Regular City Commission Meeting Agenda

Tuesday
January 24, 2023
7:00 PM

Proposal: Major Site Plan application seeking approval for 62 multi-family dwelling units (apartments) with a revision to the existing parking lot seeking a variance for setbacks and parking reduction.

Attachment: B'nai B'rith Site Plan

A6.11

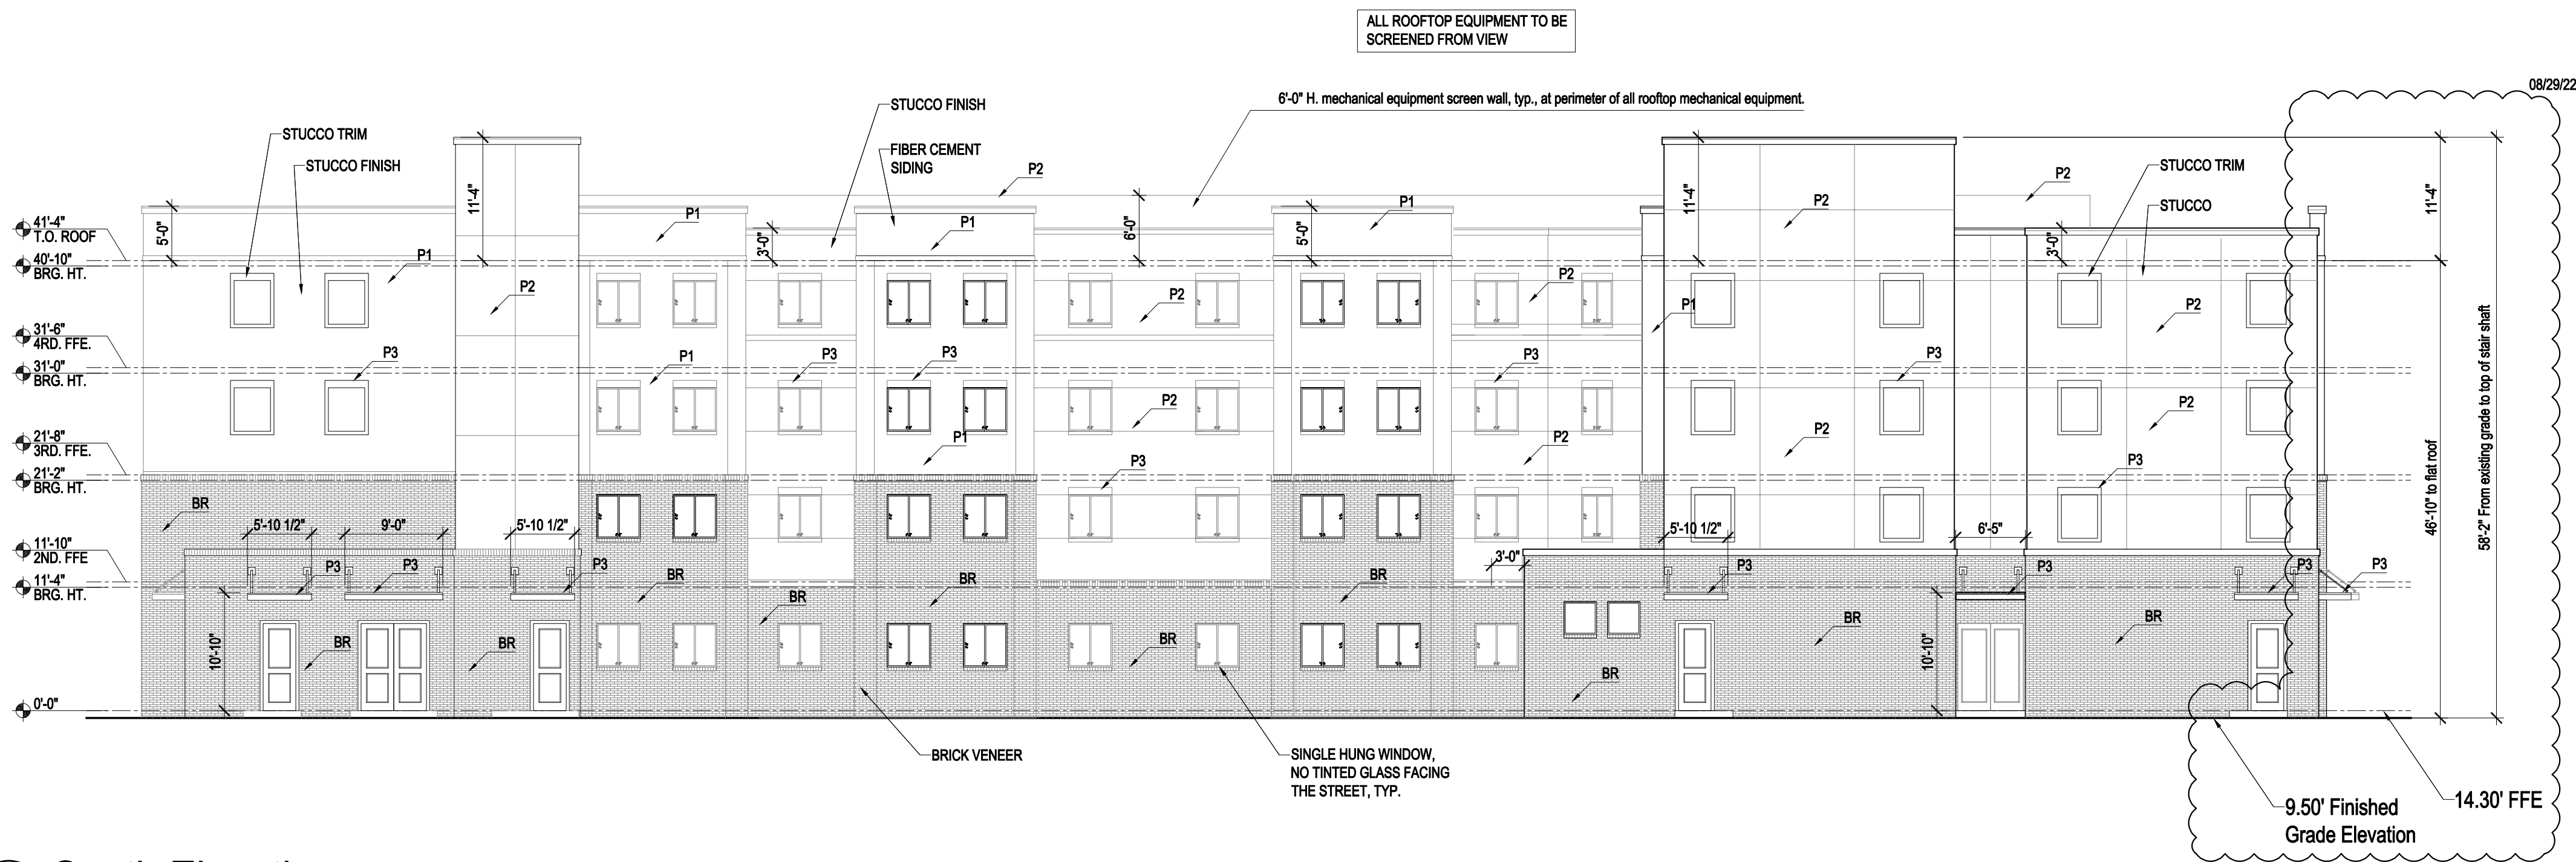
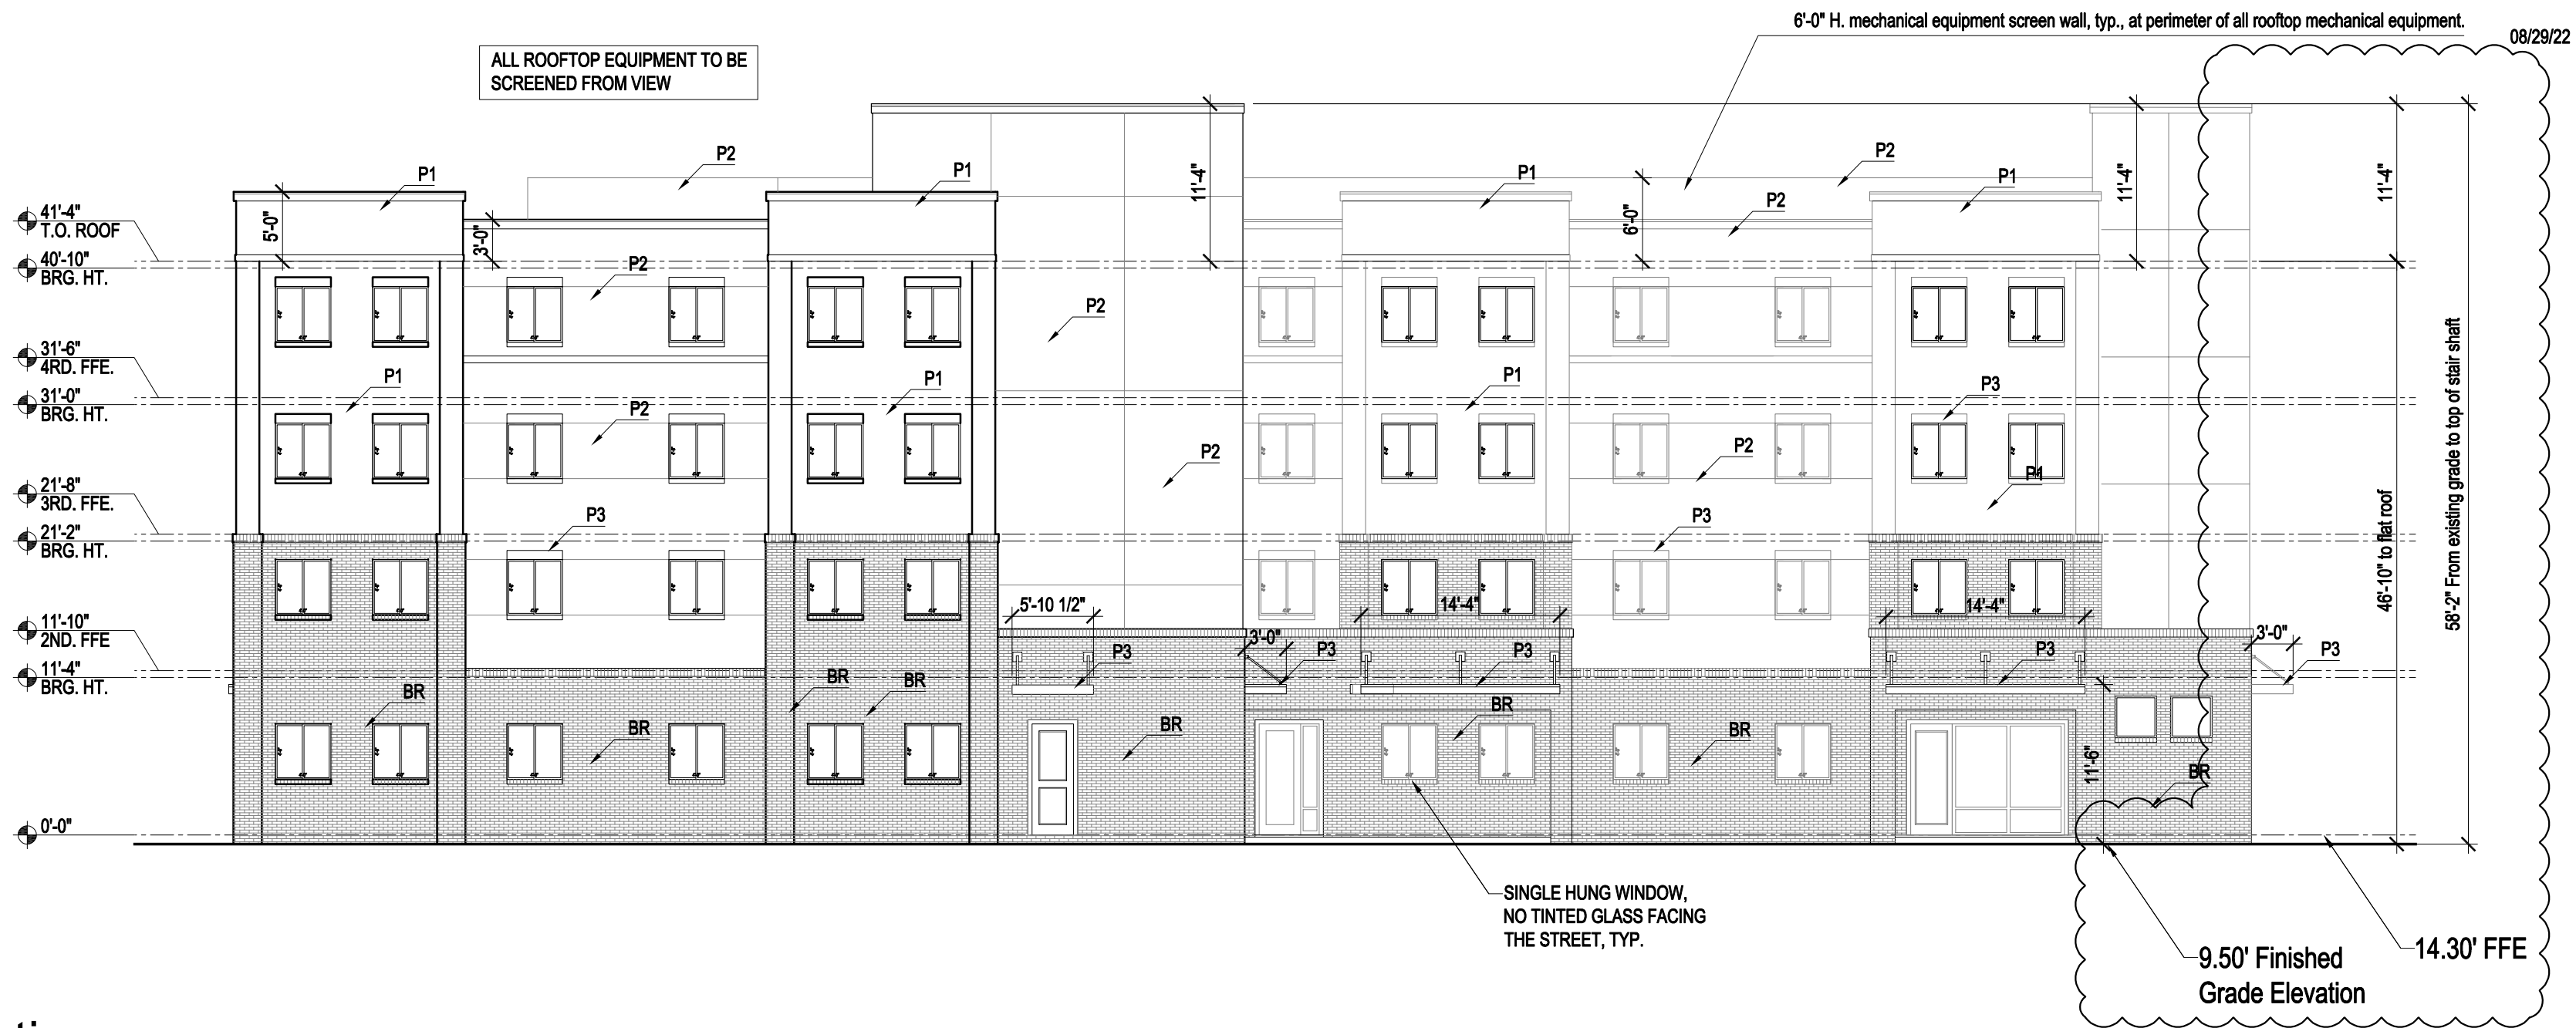
1.c.	Site Plan Page states building height at 53' 4", however pages A6.11 and A6.12 show building height at 41' 4". Even if the parapet was included as stated last time, the total height would be 52' 8". Applicant needs to address this continued discrepancy and show consistency on the site plan and elevations. Also, side note states 42' to roof height, when height shown is 41' 4". This must be consistent as well. Likely the elevations, which now show the finish grade, did not factor this into the height shown on the elevation pages.

5.b.	Comment partially addressed. Finish grade is not demonstrated on all elevation sheets and provide the building height to the top of the roof, not the roof parapet. Revise Sheet A6.11 to demonstrate the proposed building height is accurately and consistently identified on all sheets per Code.
